RAI 03.07.02-24, Supplement 1, Revision 1**QUESTION:****Follow-up Question to RAI 03.07.02-15 (STP-NRC-100036)**

RAI 03.08.01-9, Revision 2**QUESTION:****Follow-up to Question 03.08.01-6**

RAI 03.08.04-17, Supplement 1**QUESTION:****Follow-up to Question 03.08.04-1 (RAI 2964)**

RAI 03.08.04-28, Revision 1**QUESTION:****Follow-up to Question 03.08.04-19**

Figure 3H.6-241: At-Rest Lateral Earth Pressure on the Diesel Generator Fuel Oil Storage Vault Walls

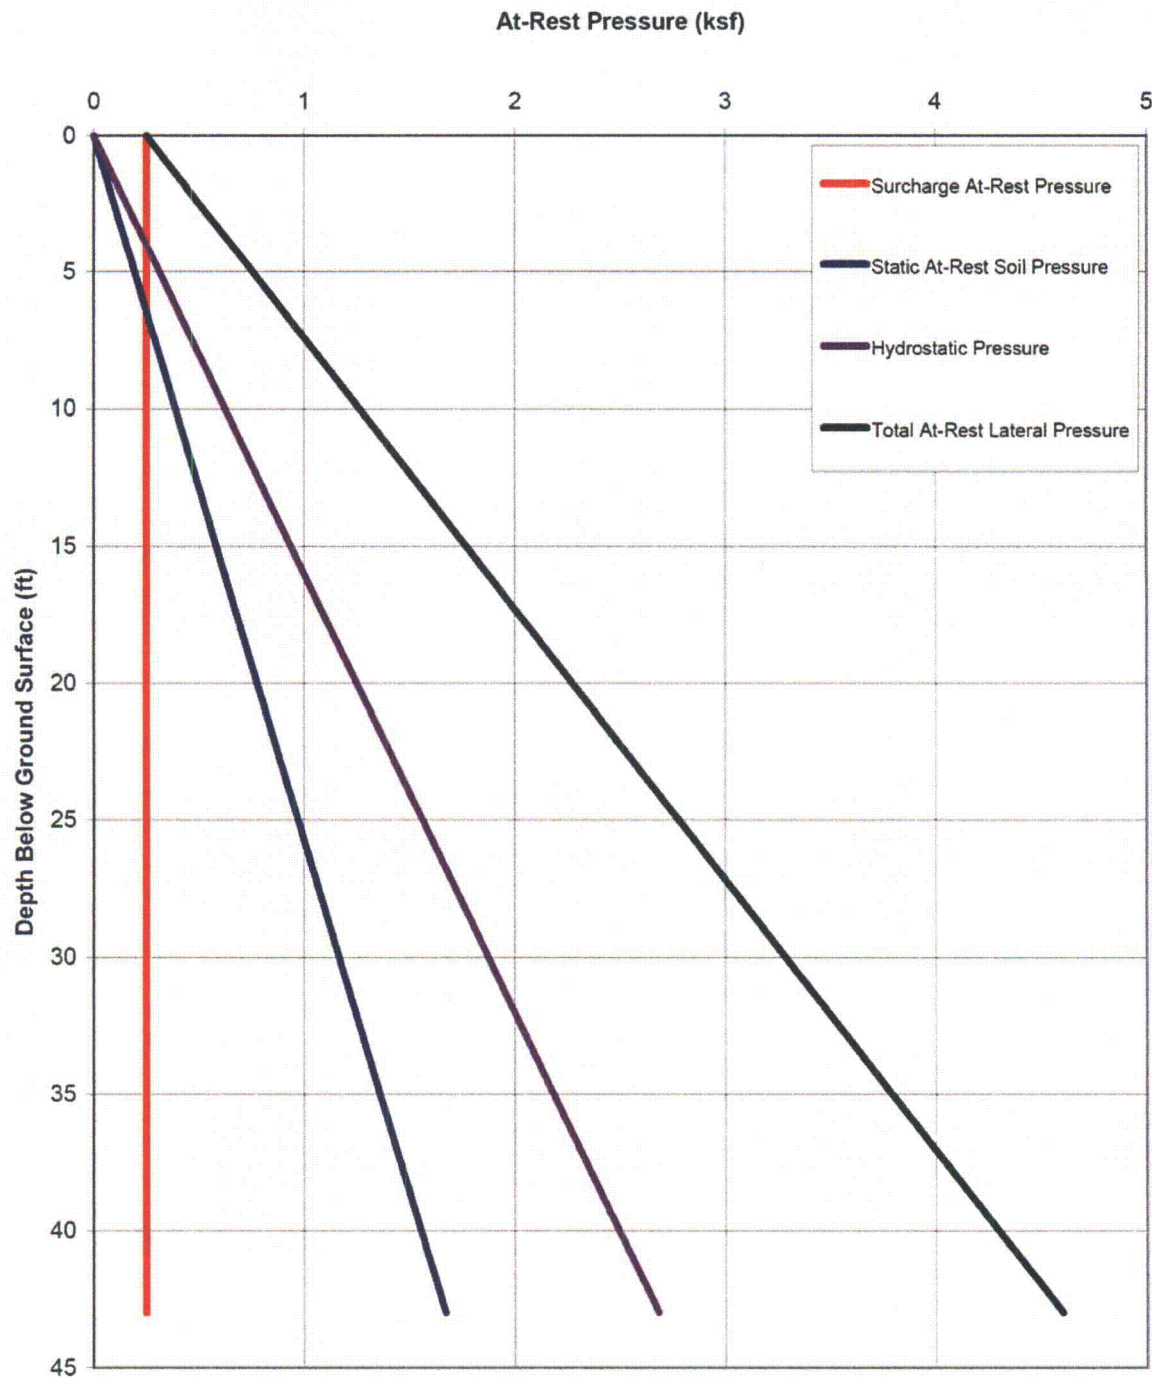
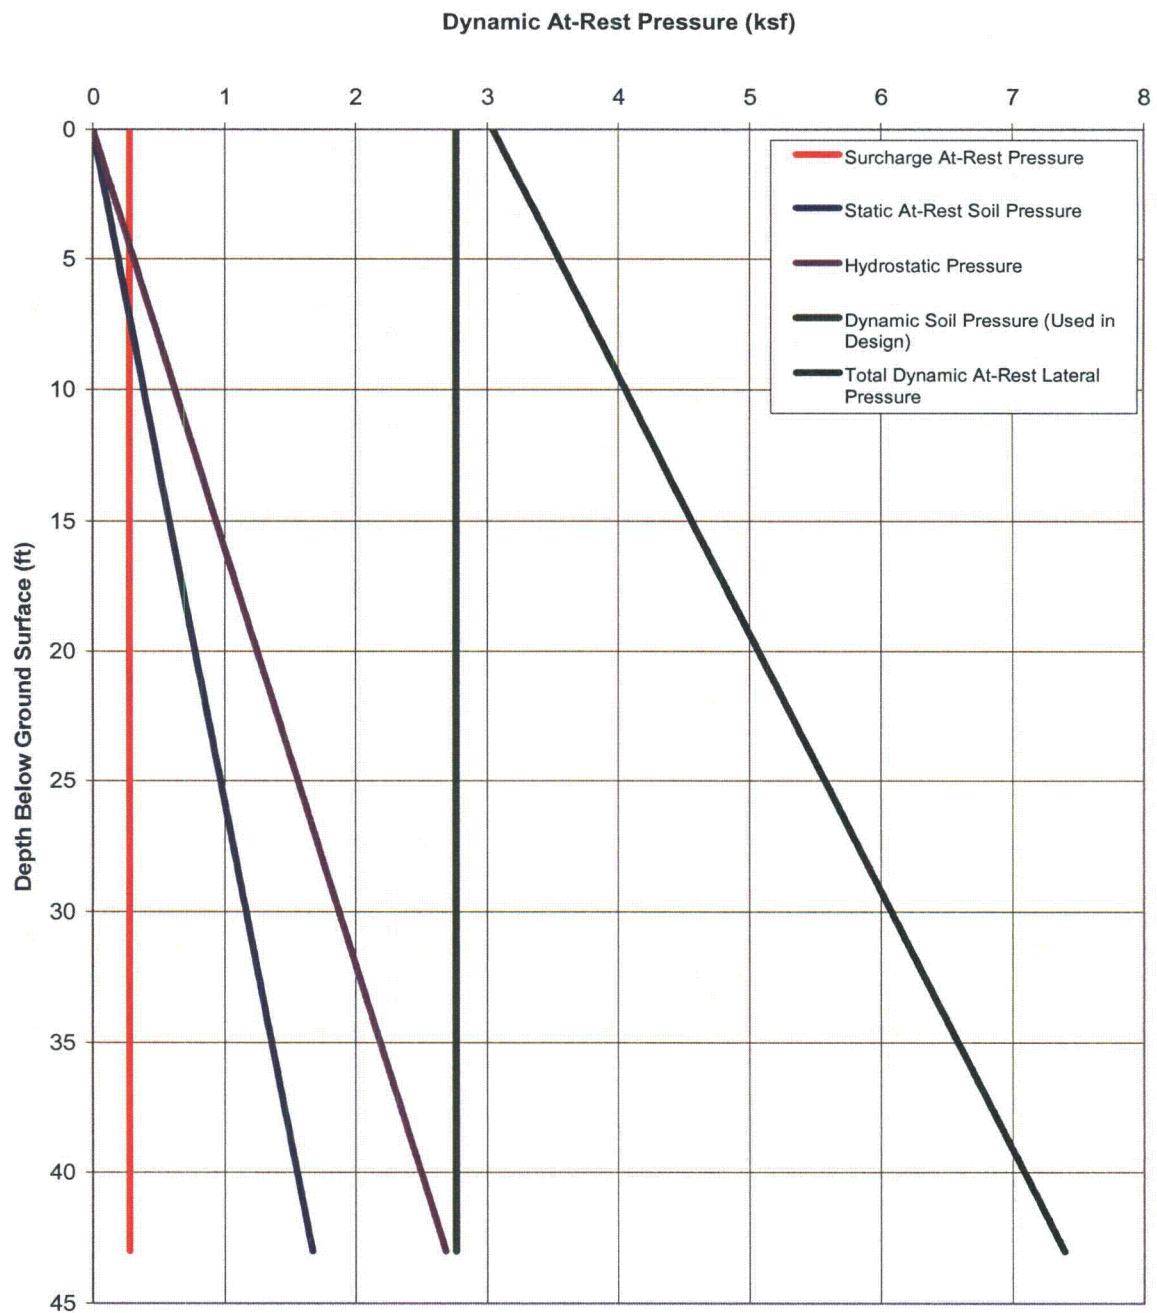
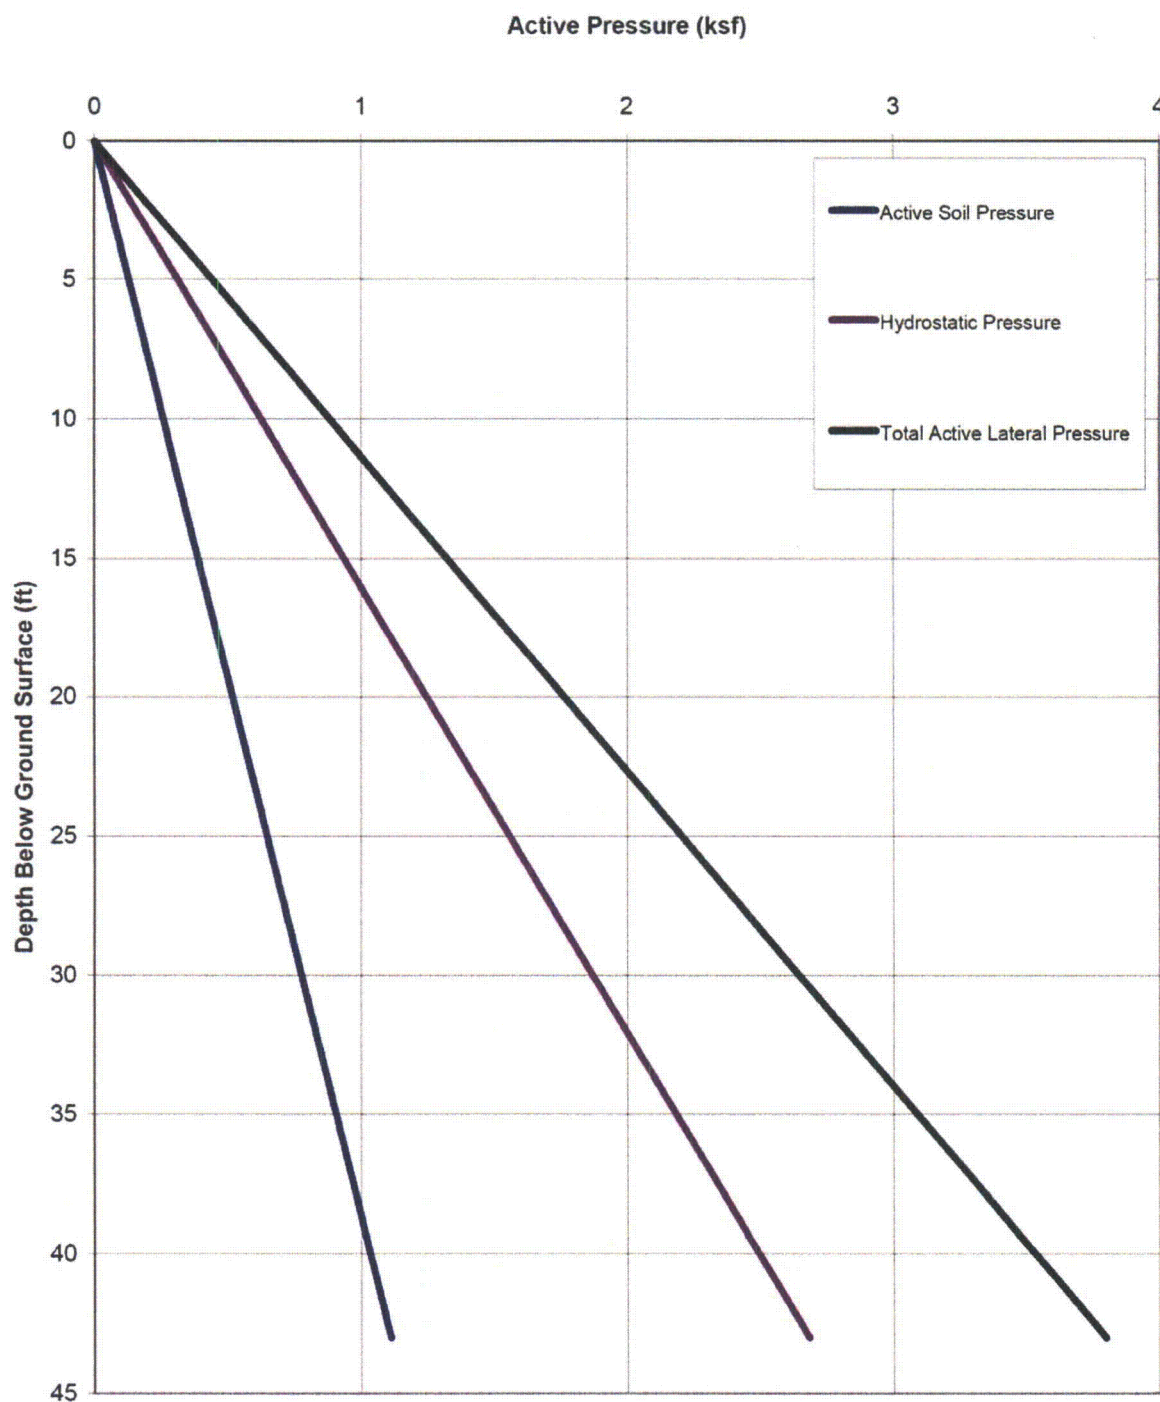
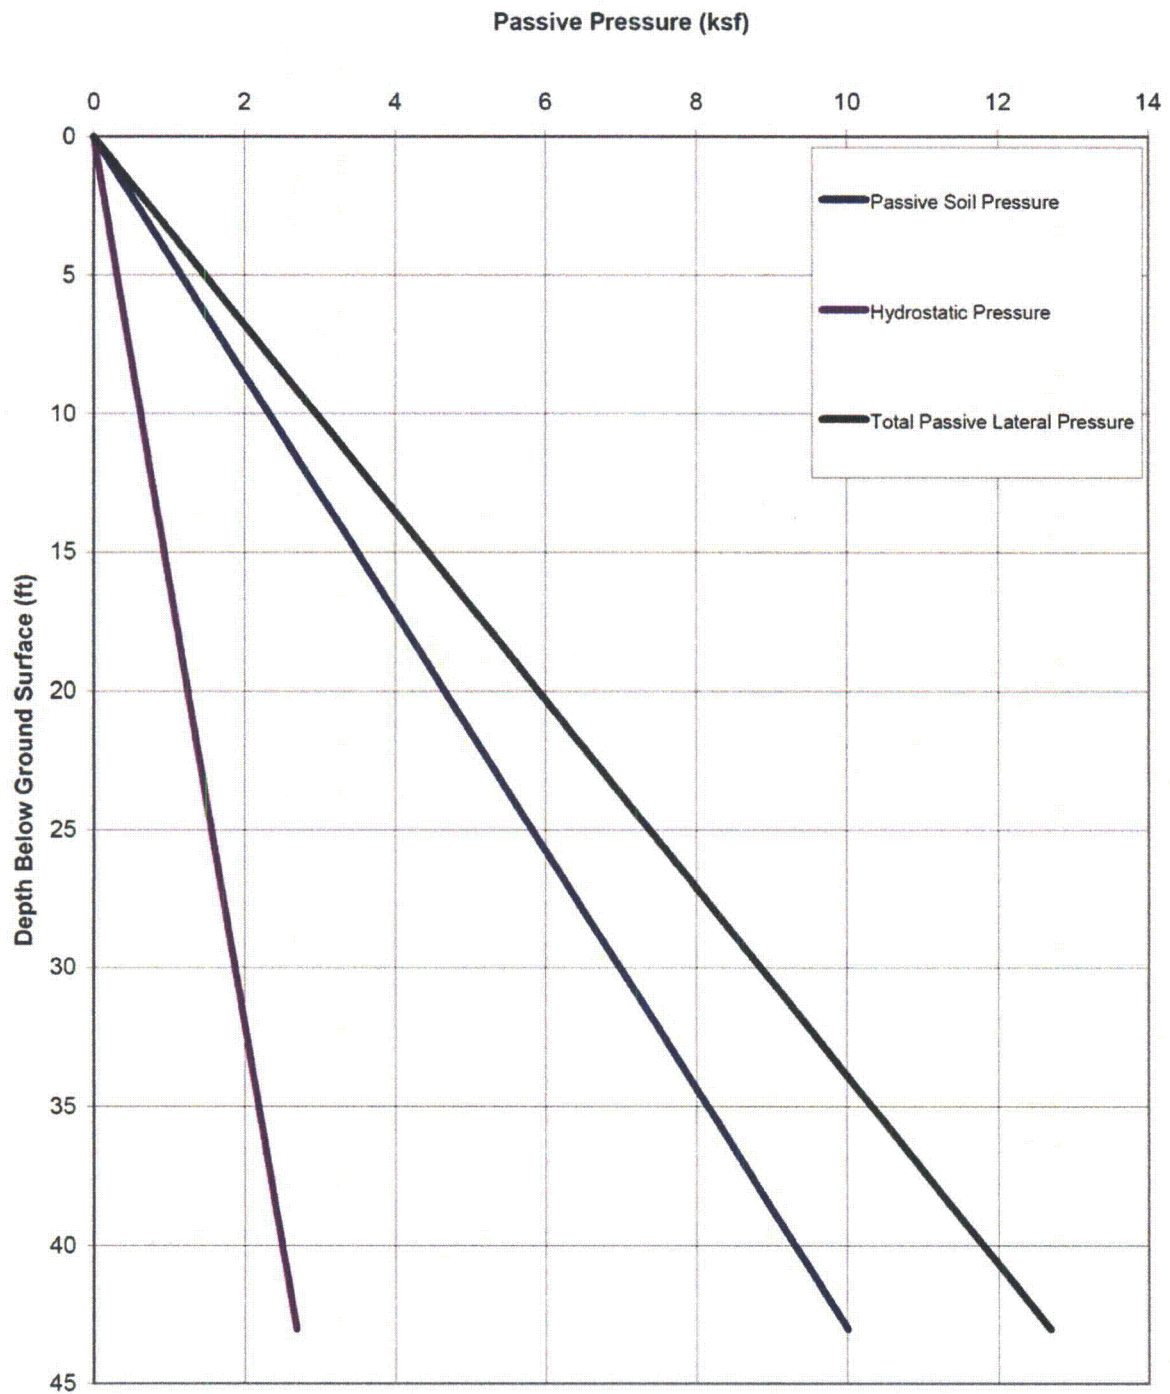
- b) For the staff to conclude that the design of structures with deep foundations, such as the Reactor Building (RB) and Control Building (CB), is satisfactory for the site, the site-specific design loads are needed to compare with the design loads used for the DCD. Lateral soil pressure is one such load. Therefore, please provide the lateral soil pressures for the RB and the CB, and compare these calculated pressures with those used in the ABWR standard plant design. Please also confirm if the effects of adjacent structures are considered in computing the lateral soil pressures, and if not, provide the justification for not doing so.

The structure-soil-structure interaction (SSSI) incremental seismic soil pressure curves for the Diesel Generator Fuel Oil Storage Vault (DGFOSV) have been provided in COLA Part 2, Tier 2, Figures 3H.6-226 through 3H.6-231, in the response to RAI 03.07.01-27, Supplement 1, Revision 1, which is being submitted concurrently with this response. The at-rest, dynamic at-rest, active, and passive soil pressure profiles are provided in Figures 3H.6-241 through 3H.6-244, included in Enclosure 1 of this response.
